Our current supplier of Oil Furnace Direct Venting Kits, **Flex-L** has discontinued manufacturing the kits we purchase from them. We have secured a new supplier; NovaFlex will supply the Flexmaster **Z-Flex** brand **Oil Furnace Double Wall Insulated Direct Vent Kits**. We appreciate your patience during this transition period.

Figure 1. Flex-L Venting System

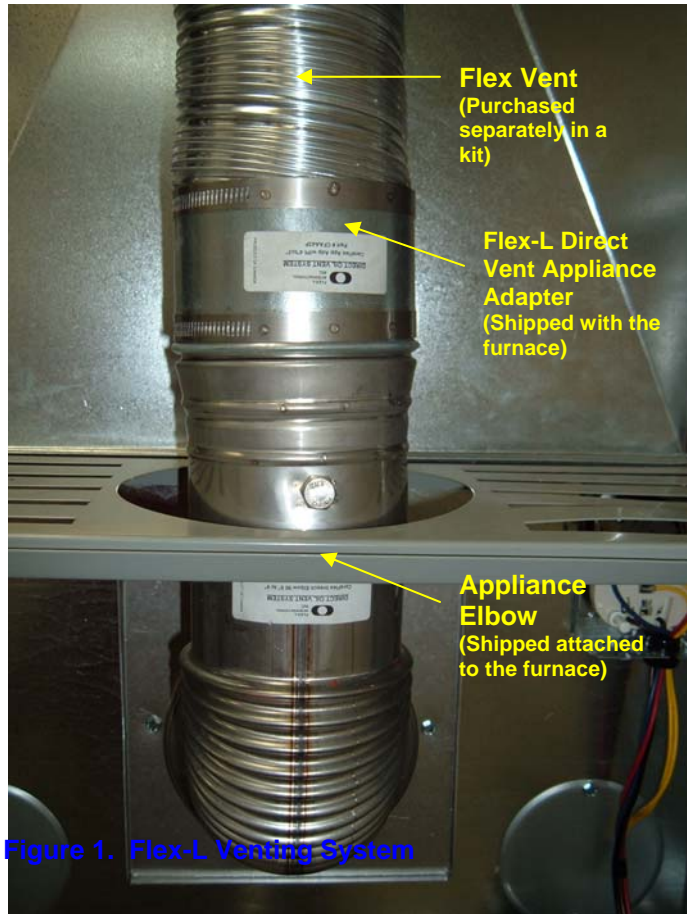
The two kits are **NOT** interchangeable. ECR supplies the Direct Vent Appliance Adaptor (Fig. 1 or 2) with every Direct Vent Oil Furnace manufactured. If the Direct Vent Oil Furnace has a **Flex-L** appliance adaptor inside (Fig. 1) a **Flex-L** vent kit must be used. If the furnace has a **Z-Flex** appliance adaptor inside (Fig 2.) a **Z-Flex** vent kit must be used.

The **Flex-L** flex vent (Fig 1.) attaches to the appliance adaptor and termination adaptor in a clockwise motion. The **Z-Flex** direct vent appliance adaptor (Fig. 2) and termination adaptor attach in a counter clockwise motion.

The required venting kit part number is listed on the shipping label placed on the packaging of the unit, as well as inside all Direct Vent Oil Furnaces next to the burner. **Direct Vent Oil Furnaces with a Z-Flex appliance adaptor inside will state "FOR USE WITH Z-FLEX DOUBLE WALL INSULATED VENTING" on all labels.** Always refer to these labels before selling or installing a Direct Vent Oil Furnace to ensure the correct venting kit is used.

HML and WML units manufactured after September 17, 2007 will be shipped with the new **Z-Flex** appliance adaptor inside the unit.
